## ATTACHMENT 2

### WMAL Site Plan: Significant Changes Since Preliminary Plan Approval/ Initial Site Plan Submission

*Figure 3: Comparison of the area just north of the school site (in green) in the Preliminary Plan (left, with townhouses) and in the Site Plan (right, as a 0.5-acre parcel of open space)*

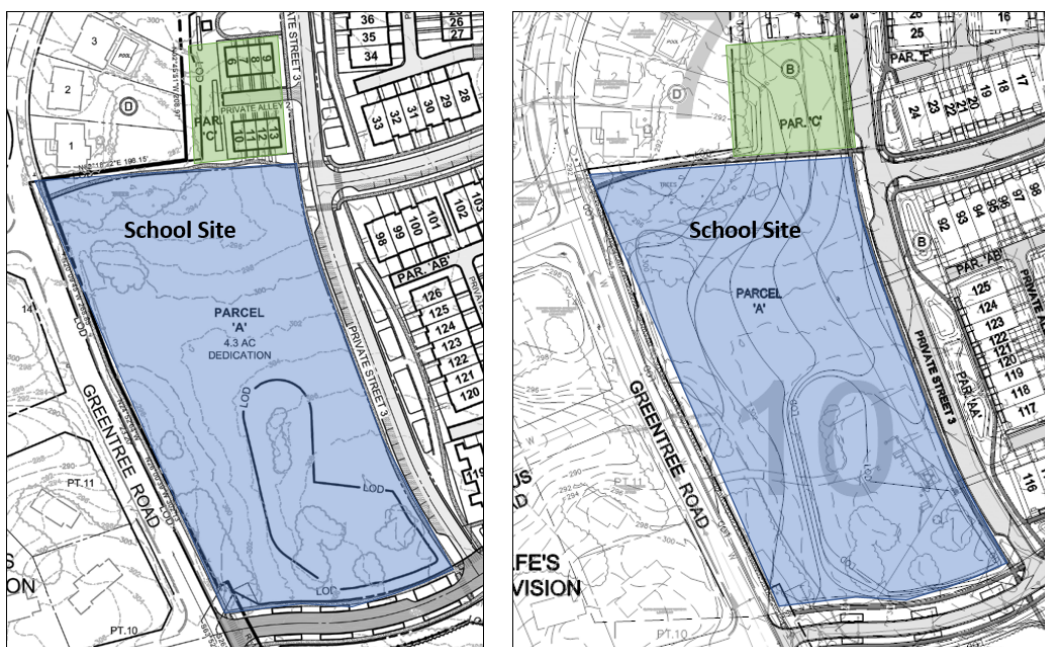
- Addition of a 0.5-acre open space parcel north of the school parcel, consistent with the Planning Board's request during the hearing to approve the Preliminary Plan
